SUBJECT: Transmittal of Westinghouse Responses to US NRC Requests for Additional Information on the AP1000 Application for Design Certification

AP1000 DESIGN CERTIFICATION REVIEW

Response to Request For Additional Information

Figure 3.8.5-2 (Sheet 1 of 2)
Isometric view of finite element model

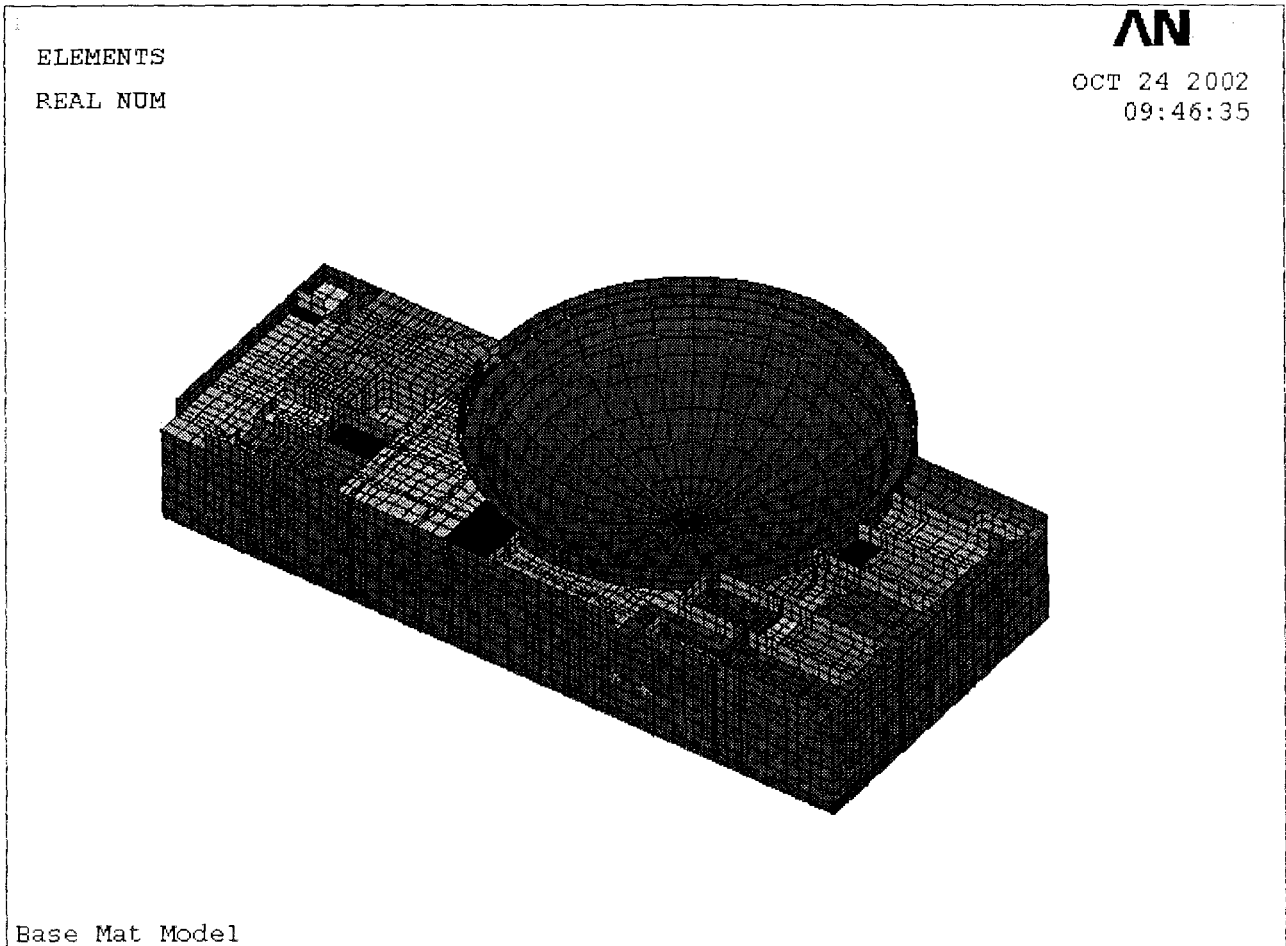
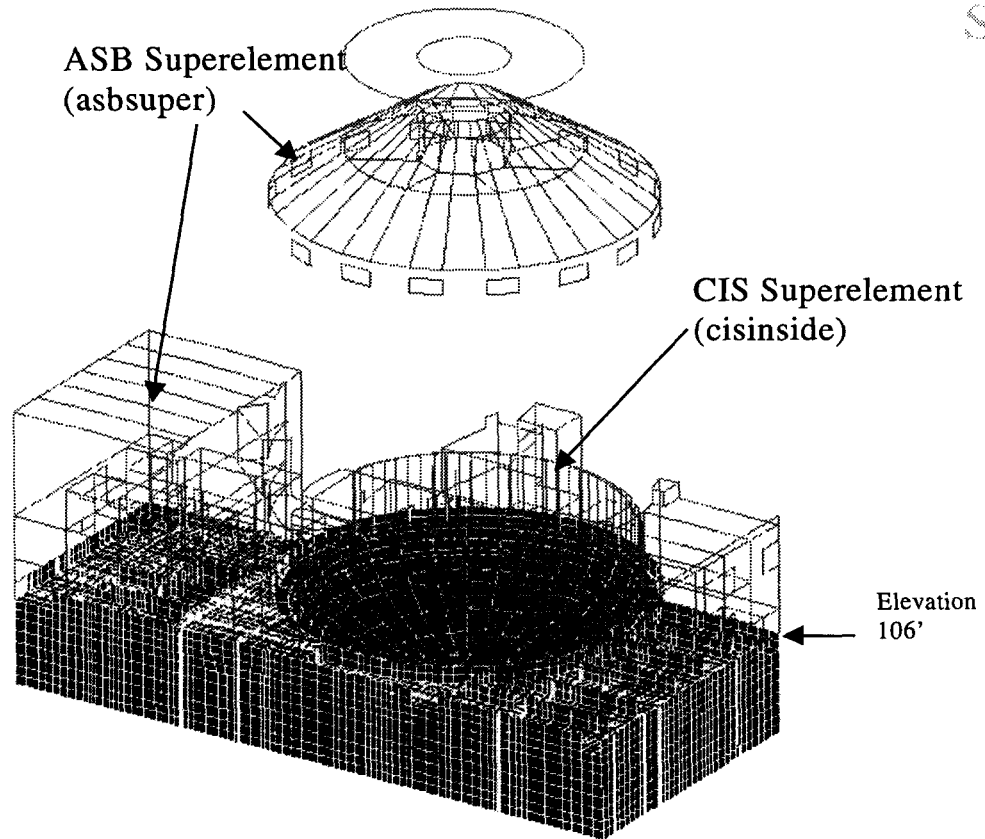
Part B. In its response, Westinghouse indicated that the design will be acceptable for hard rock having an allowable bearing capacity of 450 ksf. The staff raised a concern that this is considered an extremely high value of "allow bearing capacity", even for hard rocks, and will be difficult for the COL applicant to substantiate. The staff also identified that the response also does not indicate whether this definition refers to strength or displacement considerations. In addition, the review of the Civil/Structural Criteria document indicated that hard crystalline bedrock is to have an allowable bearing capacity of 4 ksf. Westinghouse agreed to clarify these discrepancies.

Replace subsection 3.8.5.4.1 and Figure 3.8.5-2 with the following:

The three-dimensional finite element model of the basemat includes the structures above the basemat and their effect on the distribution of loads on the basemat. The finite element models of the auxiliary building above elevation 106' and the containment internal structures inside containment are reduced to substructures (superelements) within ANSYS. These superelements are then included in the detailed finite model of the basemat which includes the auxiliary building below elevation 106' and the mat below the containment vessel. The finite element model of the basemat is shown on sheet 1 of Figure 3.8.5-2. The model of the basemat including the superelements is shown on sheet 2.

Figure 7.1.1-1

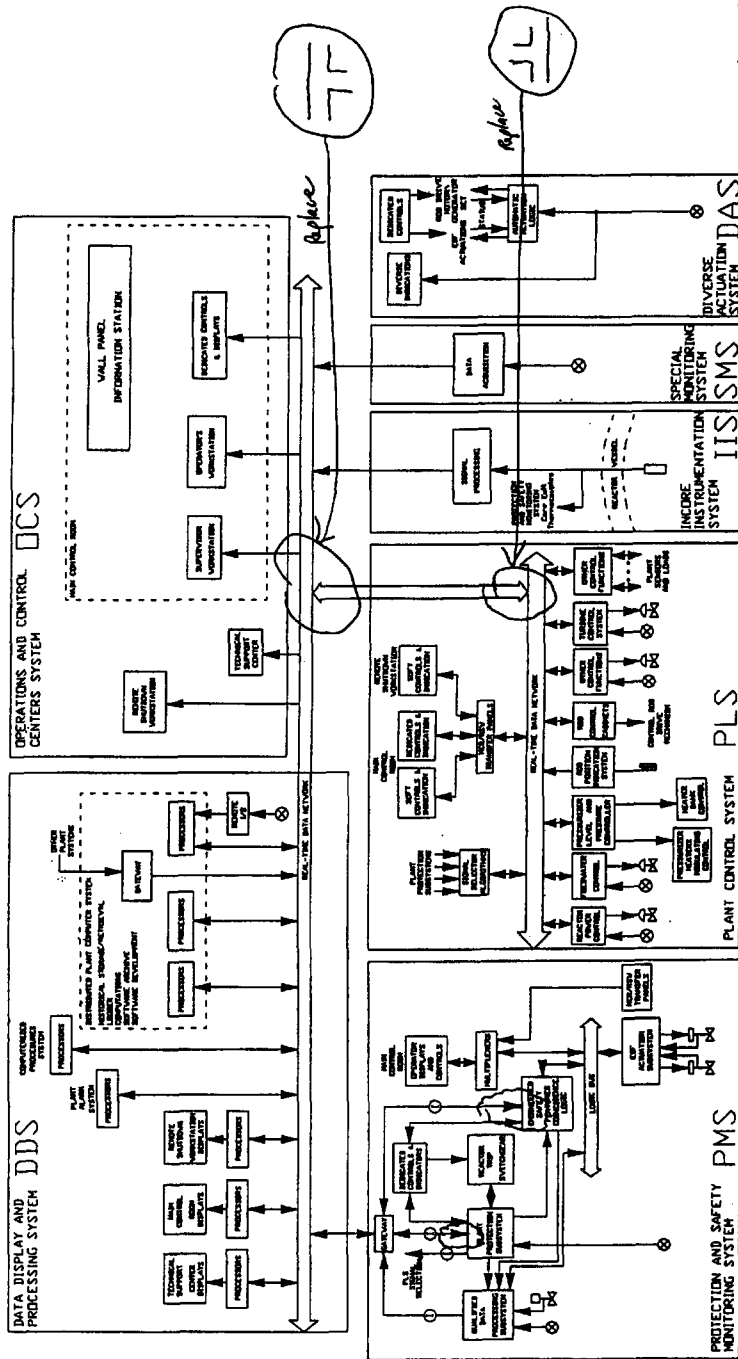
Describe the architecture of the real-time data network and how the information is used to control and monitor the plant. This includes the network in the PLS and the one that interfaces with the DDS, DCS PLS, IIS, SMS and the DAS.

Chapter 7 of the DCD currently depicts the real-time data networks in two segments. The first segment is located entirely within the Plant Control System (PLS). The second segment resides primarily in the Data Display and Processing System (DDS), but also interfaces to the Protection and Safety Monitoring System (PMS), the Incore Instrumentation System (IIS), and the Special Monitoring System (SMS). That segmentation is not driven by a functional requirement and will be removed from DCD Figure 7.1-1.

3. Supervision and Limited Control of the Safety Systems - The real-time data network is connected to a Gateway in each of the safety divisions. The Gateway provides electrical and functional isolation between the safety system and the non-safety system. The primary data flow between the systems is the transfer of plant status, safety system status, and diagnostic information from the safety system to the non-safety systems. The primary use of this data is for plant computer functions and historical data logging. Data flow from the non-safety system into the safety system is used primarily for manual control of the ESF system. These control signals are validated by the safety system prior to action being taken. The validation either takes the form of logic that prevents inhibiting of an automatic safety function or confirmation of action with the operator where there is no automatic safety function. Further details are available in Appendix 4 of the Common Q Topical Report. DCD Figure 7-1.1 will be revised within the PMS to make the arrows between the gateway and both the plant protection subsystem and the engineered safety features coincidence logic bi-directional. Figure 7.1-2 will be revised to make the arrow between the gateway and the plant protection subsystem bi-directional.

Figure 7.1-2

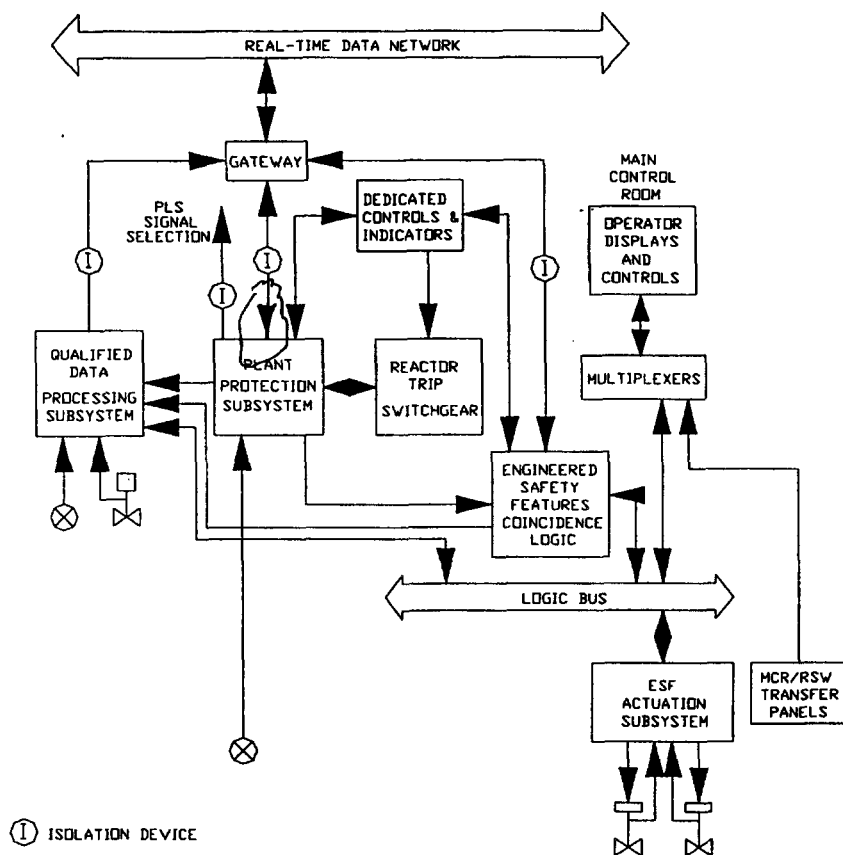
Revise RAI response and Tier 1 to add new ITAAC to address limits to the communication between the nonsafety PLS and safety PMS so that nonsafety systems will not adversely impact the safety system.

Revise RAI response and Tier 2 with new discussion on functional requirements of the gateway. Also must capture the functional independence between the nonsafety systems and the PMS.

The communication functions provide information from the plant protection subsystem, the ESF coincidence logic, the ESF actuation subsystems, and the QDPS subsystems to external systems. This includes outputs to the plant control system and the data display and processing system. Isolation devices provide electrical isolation between the protection and safety monitoring system and the external systems. **The communication functions also provide soft control information from the non-safety system to the safety system for operator-initiated actuation and component control.**

The communication functions are accomplished via channelized gateways as shown in Figure 7.1-1.

Figure 3-4
Primary Sampling System

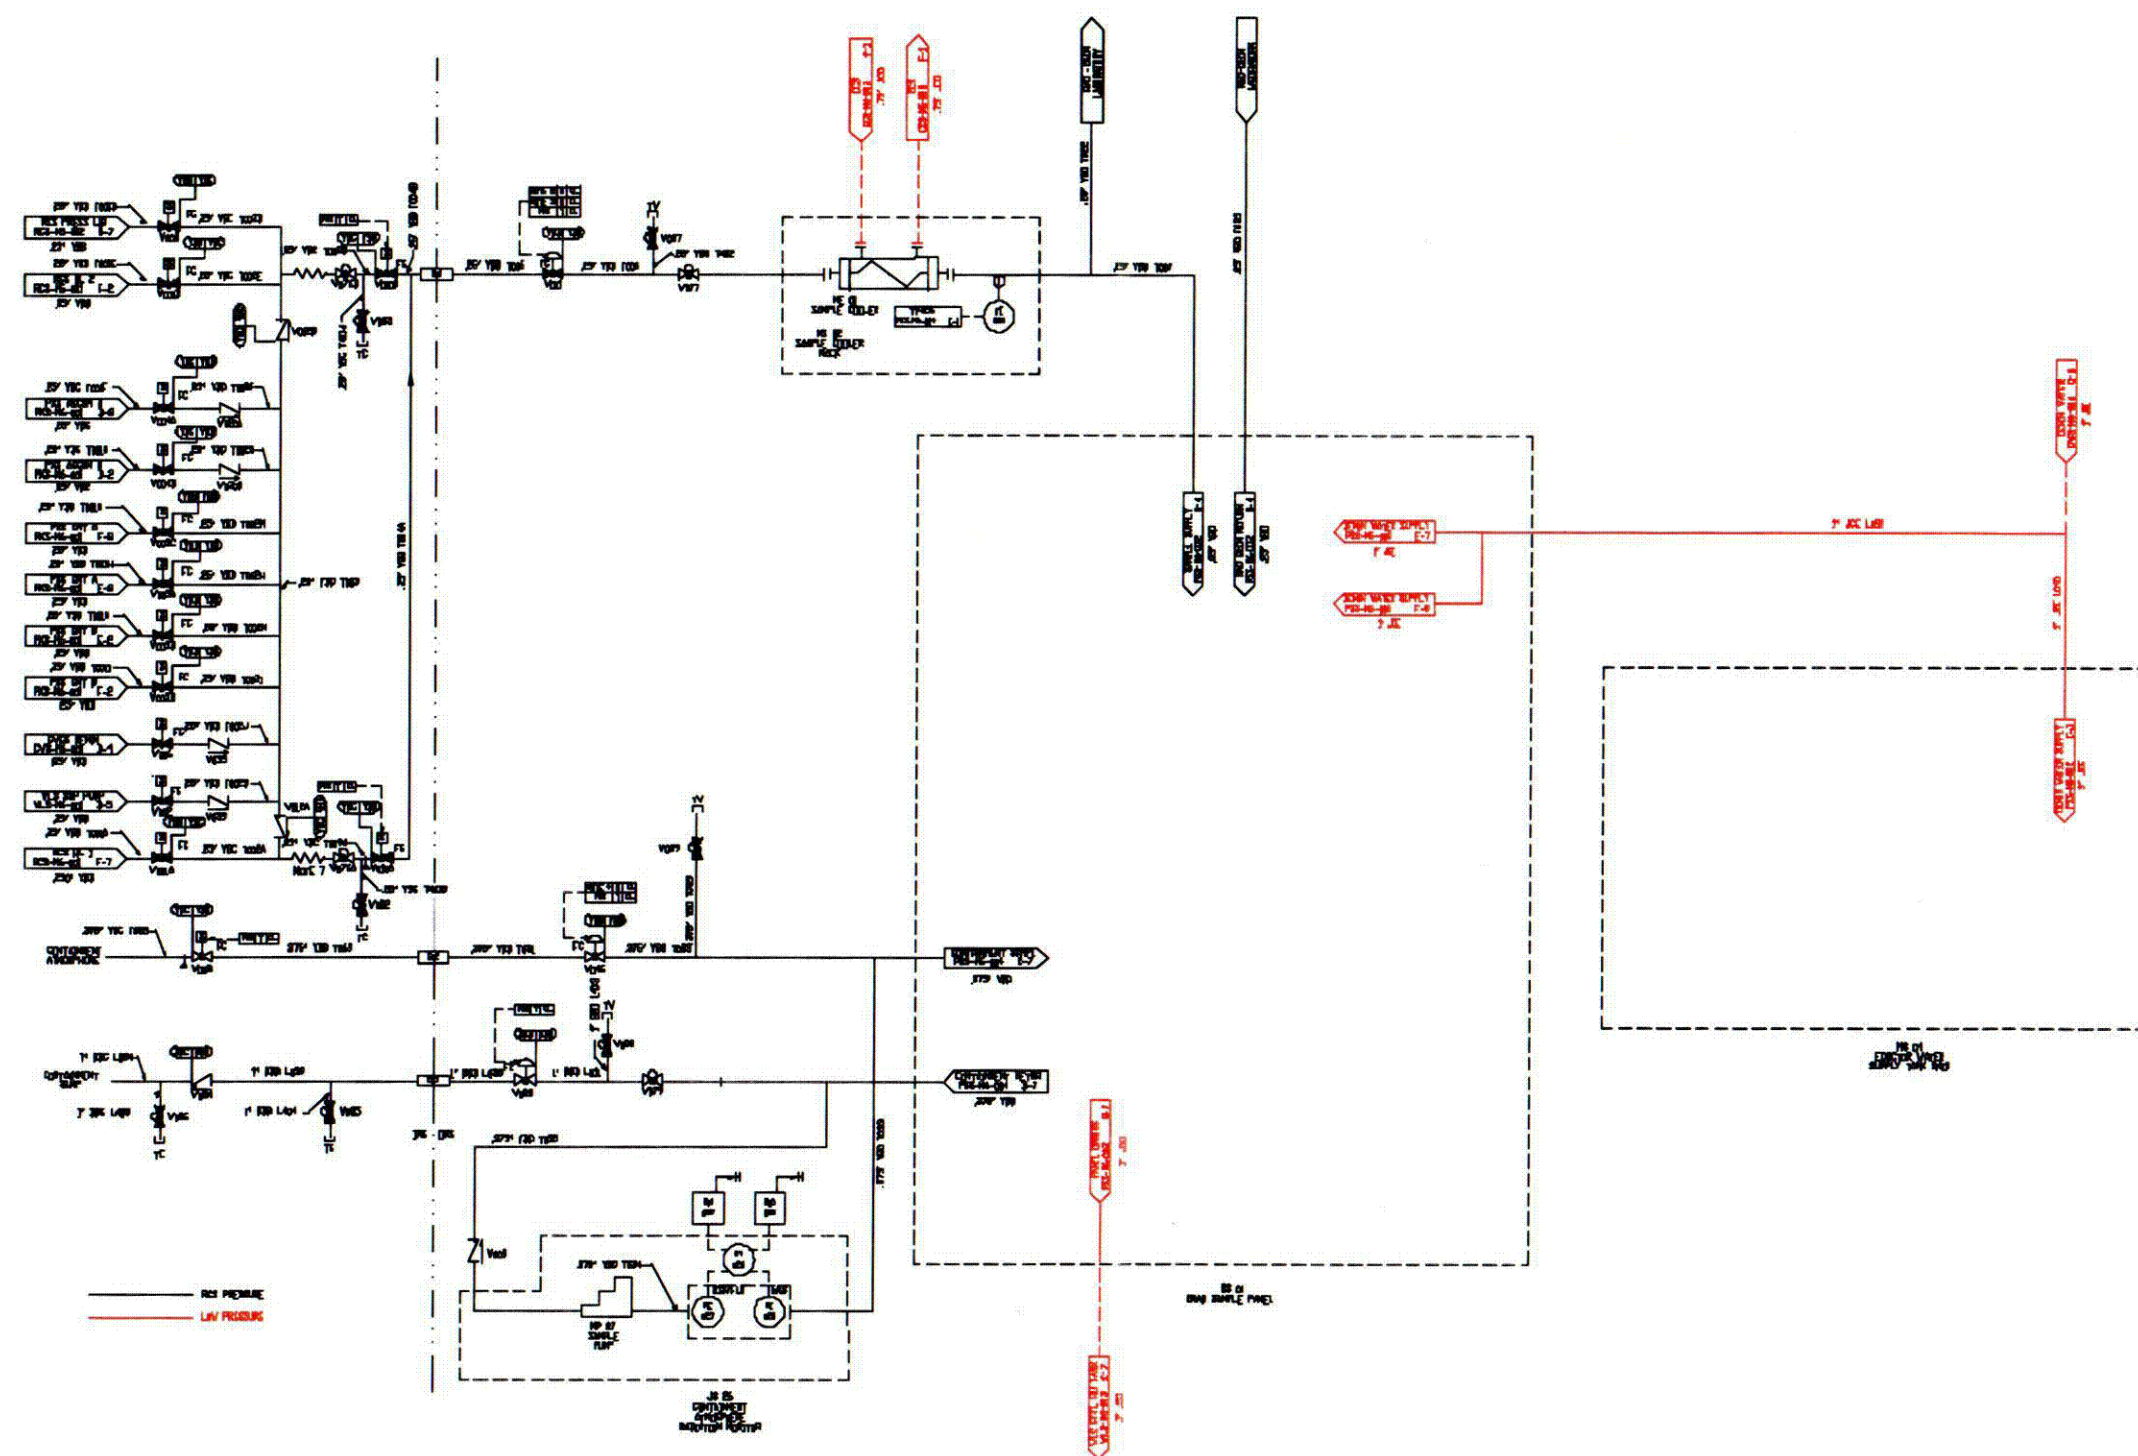
6. Section 3.6.1 describes the demineralized water transfer and storage system interface with the primary sampling system. It references Figure 3-4, and discusses the DWS isolation valve V007, check valve V013, and isolation valve V037 (to the liquid waste system degasification). They are not shown in Figure 3.4. (Figure 3-4 and DCD Fig 9.3.3-1 do not show demineralized water transfer system).

Discuss and modify the figure, if necessary.

5. The comments about makeup being within the capability of the normal makeup system are intended to indicate that this event is a "leak" rather than a "LOCA."
6. The DWS interface with the PSS is inside containment. After discussions between Westinghouse and the NRC by phone it as determined that no modifications are required.
7. This relief valve is shown on the DWS piping and instrumentation diagram.

Figure 3-5 Demineralized Water System Supply Header Inside Containment

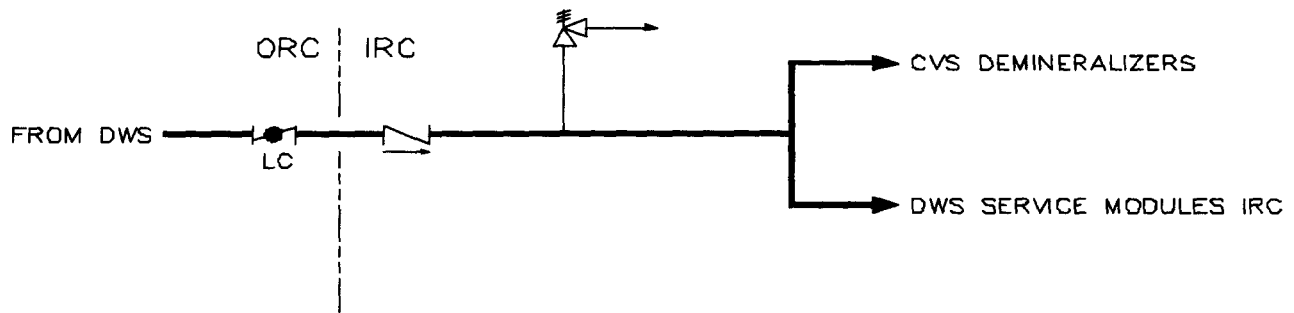
7. Section 3.6.2 states that a relief valve has been added to the DWS header inside containment to preclude the possibility of overpressurizing the DWS.

A relief valve has been added to the DWS header inside containment to preclude the possibility of overpressurizing the DWS for these events. This relief valve, shown in Figure 3-5, discharges to the containment.
